**EXPEDITED**  
**MONTGOMERY COUNTY HISTORIC PRESERVATION COMMISSION**  
**STAFF REPORT**

<b>Address:</b>	23335 Frederick Road, Clarksburg	<b>Meeting Date:</b>	9/9/2020
<b>Resource:</b>	Contributing Resource (Clarksburg Historic District)	<b>Report Date:</b>	9/2/2020
<b>Applicant:</b>	Aries Investment Group (Clarksburg), LLC (Joseph Wojciechowski, Architect)	<b>Public Notice:</b>	8/26/2020
<b>Review:</b>	HAWP	<b>Tax Credit:</b>	N/A
<b>Case Number:</b>	13/10-20B	<b>Staff:</b>	Michael Kyne
<b>PROPOSAL:</b>	Rear door alteration

**PROPOSAL:**

FIRST FLOOR  
PLAN - PROPOSED

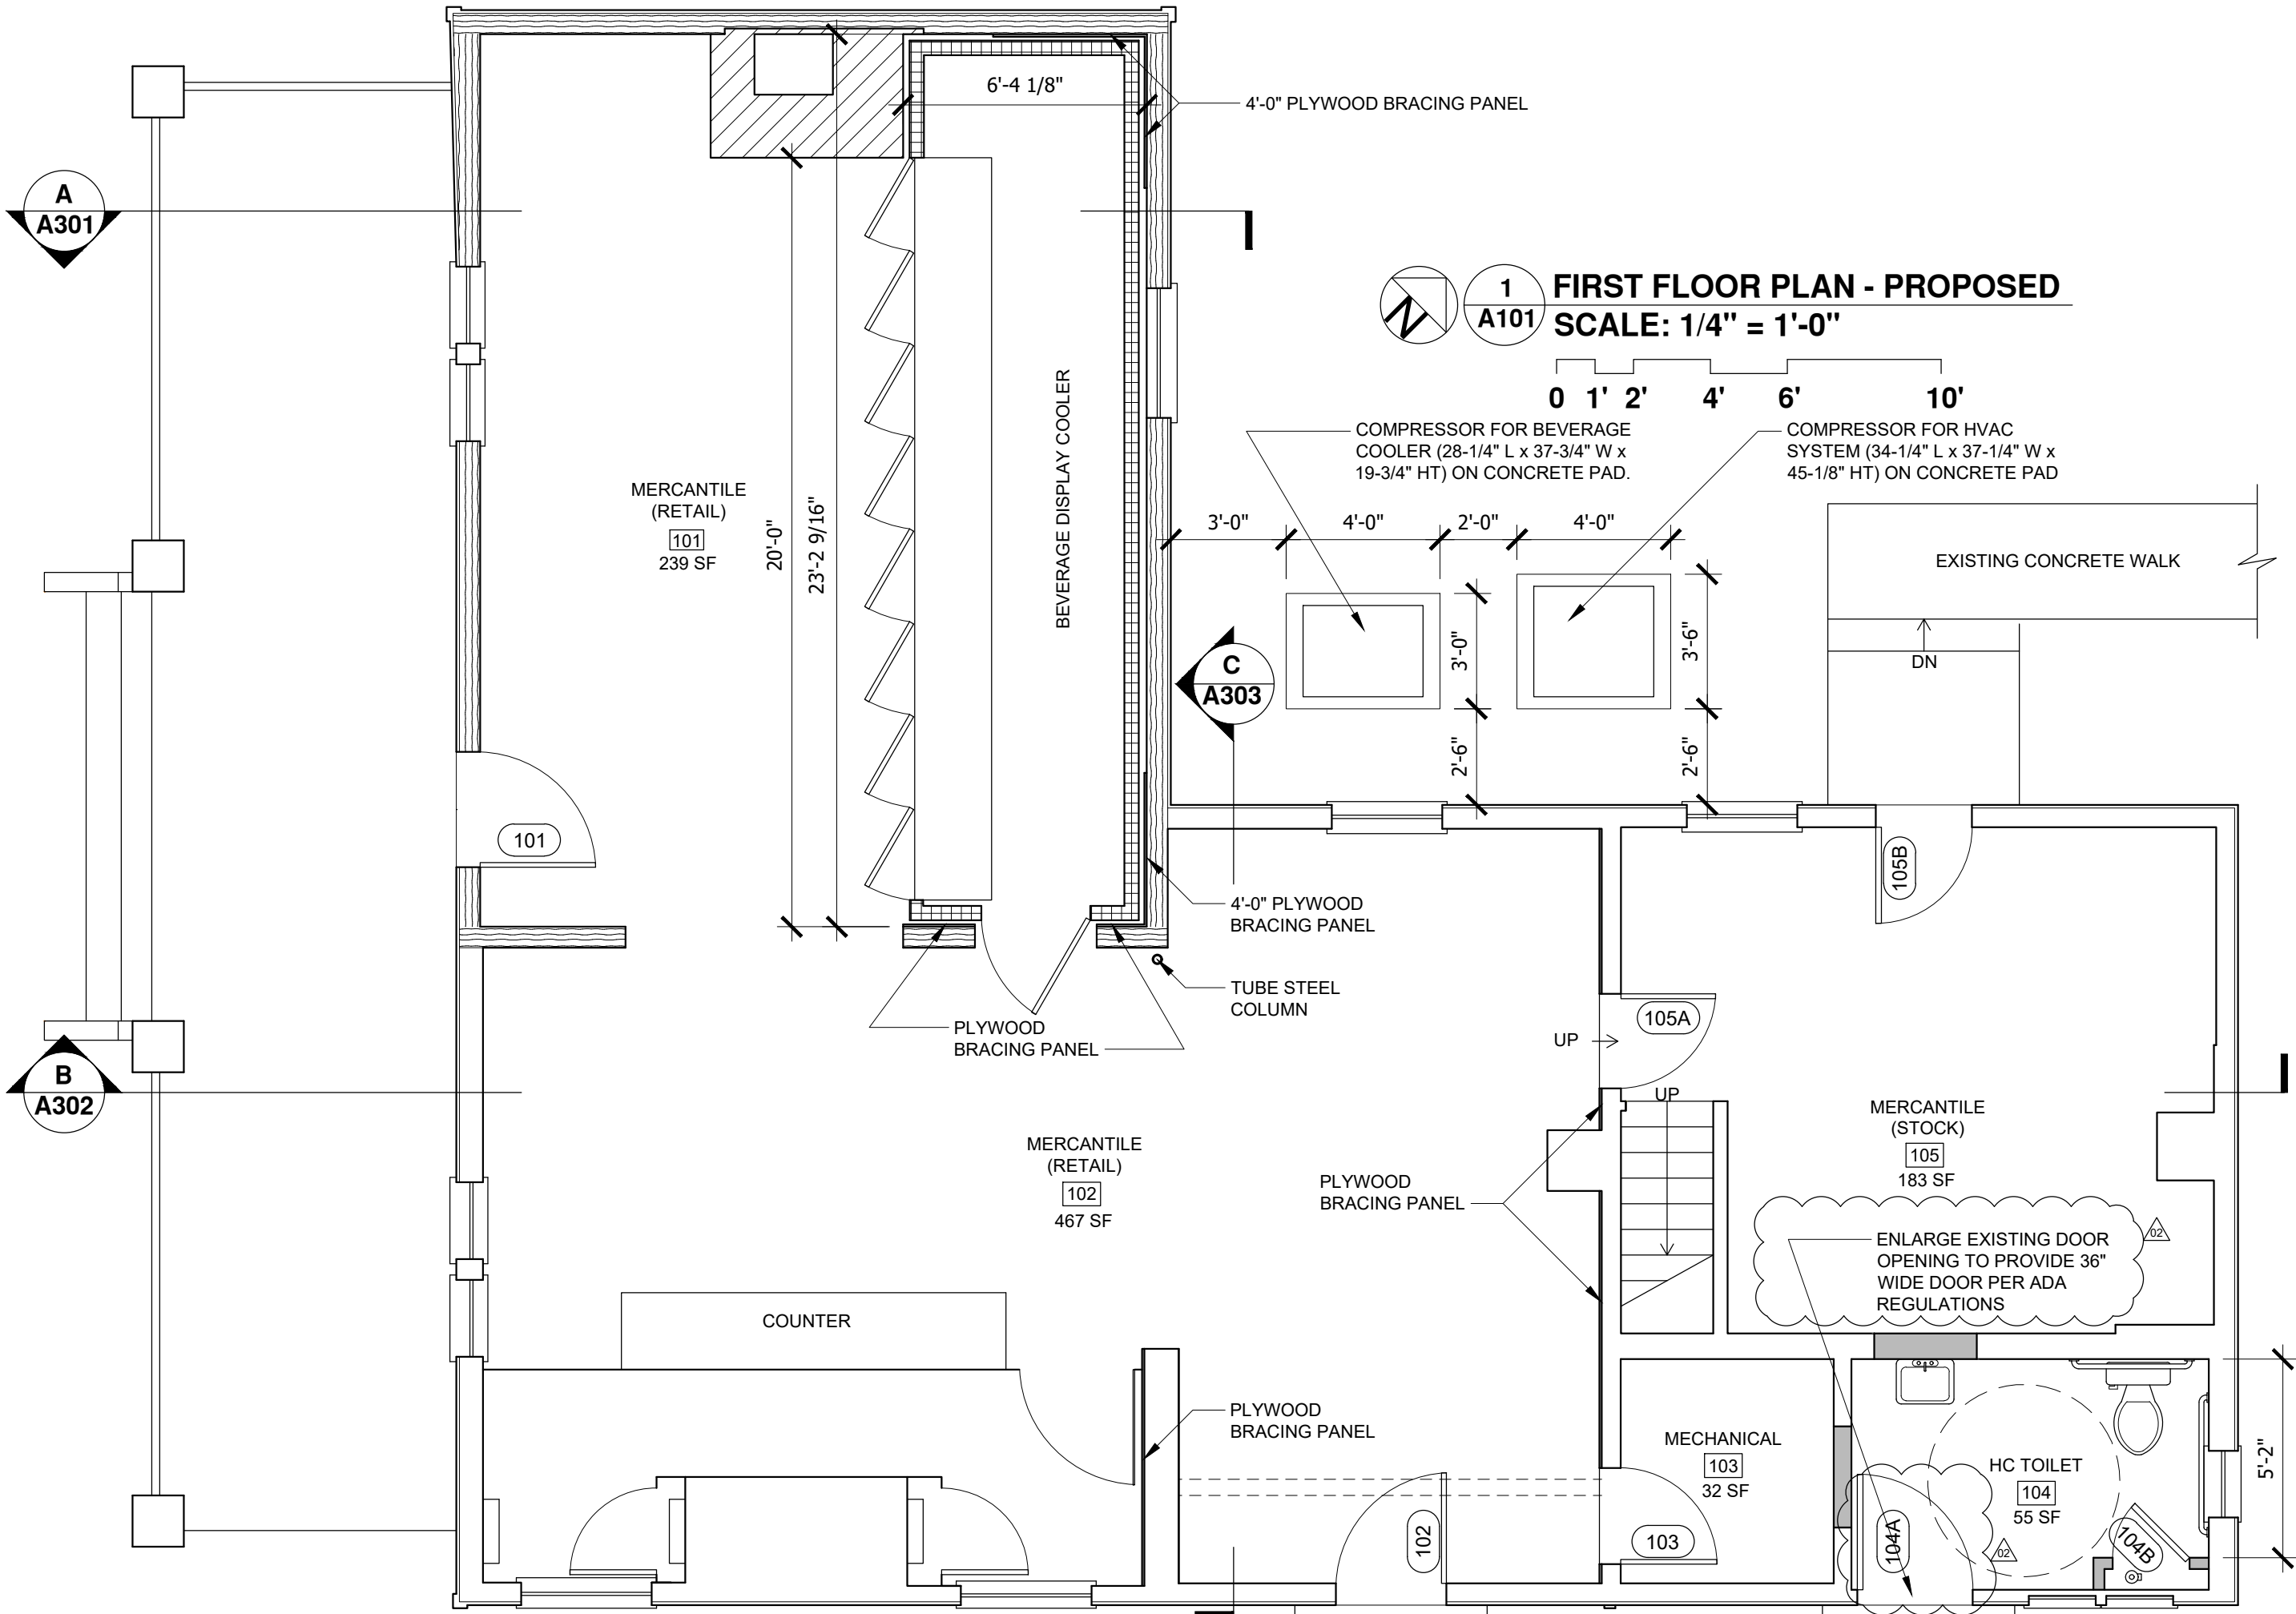
- Remove an existing non-historic 6-panel door on the southeast (rear/right) elevation of the existing rear ell.
- Enlarge the existing door opening by 4" to a final clear width of 3' wide for ADA compliance.
- Install a new 6-panel steel exterior door in the enlarged opening.

A101 Plans B & 1st.pdf	Architecture and Life Safety 2nd Susp	Provide an interior access to accessible toilet room. Accessibility requirements. The provisions of Sections 705, 806 and 906, as applicable, shall apply to facilities designated as historic structures that undergo alterations, unless technically infeasible. Where compliance with the requirements for accessible routes, entrances or toilet rooms would threaten or destroy the historic significance of the building or facility, as determined by the code official, the alternative requirements of Sections 1204.1.1 through 1204.1.4 for that element shall be permitted. IEBC 1204.1 •Toilet and bathing facilities. Where toilet rooms are provided, at least one accessible family or assisted-use toilet room complying with Section 1109.2.1 of the International Building Code shall be provided. IEBC 1204.1.4	08/06/2020	Stacy Dyer
A101 Plans B & 1st.pdf	Architecture and Life Safety 2nd Susp		08/06/2020	Stacy Dyer

A101 Plans B & 1st.pdf	Architecture and Life Safety 2nd Susp	New door shall meet the clear width requirements. Door openings shall provide a clear width of 32 inches minimum. Clear openings of doorways with swinging doors shall be measured between the face of the door and the stop, with the door open 90 degrees. Openings more than 24 inches deep shall provide a clear opening of 36 inches minimum. There shall be no projections into the required clear opening width lower than 34 inches above the finish floor or ground. Projections into the clear opening width between 34 inches and 80 inches above the finish floor or ground shall not exceed 4 inches. ADAAG 404.2.3	08/06/2020	Stacy Dyer
A101 Plans B & 1st.pdf	Architecture and Life Safety 2nd Susp	Provide maneuvering clearances at any new interior door. Minimum maneuvering clearances at doors and gates shall comply with 404.2.4. Maneuvering clearances shall extend the full width of the doorway and the required latch side or hinge side clearance. ADAAG 404.2.4 •Swinging Doors and Gates. Swinging doors and gates shall have maneuvering clearances complying with Table 404.2.4.1. ADAAG 404.2.4.1	08/06/2020	Stacy Dyer

A101 Plans B & 1st.pdf	Architecture and Life Safety Suspension Comments	Provide a 36 inch wide door which will provide a clear width of 32 inches. The required capacity of each door opening shall be sufficient for the occupant load thereof and shall provide a minimum clear width of 32 inches. Clear openings of doorways with swinging doors shall be measured between the face of the door and the stop, with the door open 90 degrees (1.57 rad). IBC 1010.1.1	06/30/2020	Stacy Dyer
A101 Plans B & 1st.pdf	Architecture and Life Safety Suspension Comments		06/30/2020	Stacy Dyer
A101 Plans B & 1st.pdf	Architecture and Life Safety Suspension Comments		06/30/2020	Stacy Dyer
A101 Plans B & 1st.pdf	Architecture and Life Safety Suspension Comments	Provide exit signs and directional exit signs throughout tenant space. Where an exit is not immediately apparent from all portions of the sales area, means of egress shall have signs in accordance with Section 7.10. NFPA 101, 36.2.10	06/30/2020	Stacy Dyer
